## PRODUCT SERVICE BULLETIN

Bulletin Number: FB 2021-01

SUBJECT: Firebird V1R1 EVO Harness container systems with adjustable Main Lift Web

STATUS: MANDATORY INSPECTION BEFORE NEXT JUMP

### DAMAGES

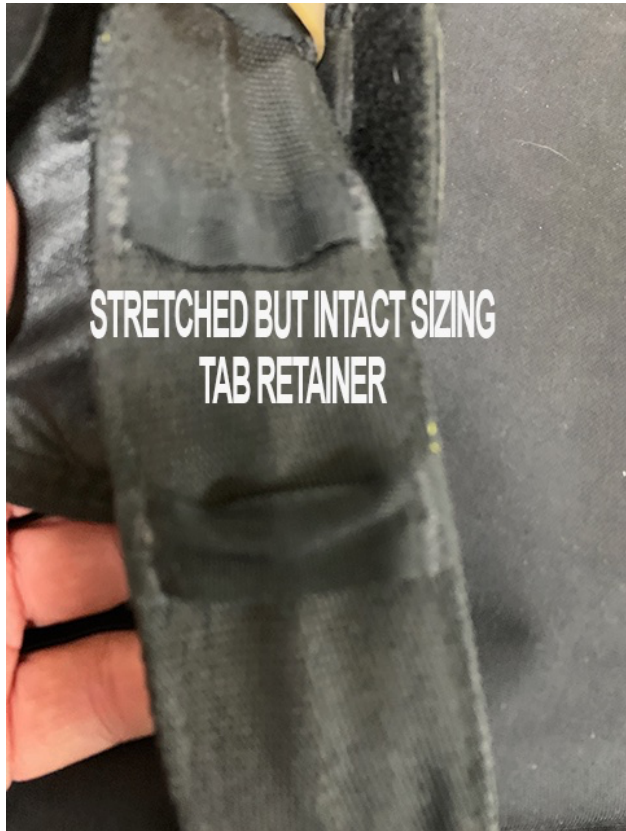
**Right** Main lift web undone, sizing safety tab ripped off and stuck under a stretched but intact sizing tab retainer (1/2" type 1), 555-2 ring installed **correctly**, **missing** spring, **NO** damage to type 4 stopper.

**Left** Main lift web threaded **incorrectly** (double routing, wrong direction, see pics), sizing safety tab attached with only a few stitches (69tex/E thread) ripped, sizing tab retainer stretched but intact, 552-2 ring installed **correctly**, spring present, **NO** damage to type 4 stopper.

The incorrectly routed webbing on the **left** side strongly indicates that, the **right** side that came undone, most likely also had been routed incorrectly.

In this incident, it appears that, the only thing that kept the webbing from coming undone, was the engaged sizing safety tab in the type 1 sizing tab retainer and that it subsequently broke under the load of the opening as **zero** damage to any other component occurred.

Therefore, we mandate a visually inspection before the next jump, to confirm the correct routing of the adjustable main lift web through a type 555-2 ring (DJA/CWH) especially if the container has been disassembled for repairs, maintenance, cleaning, or any other reason. All direct customers have been contacted by Firebird USA LLC.
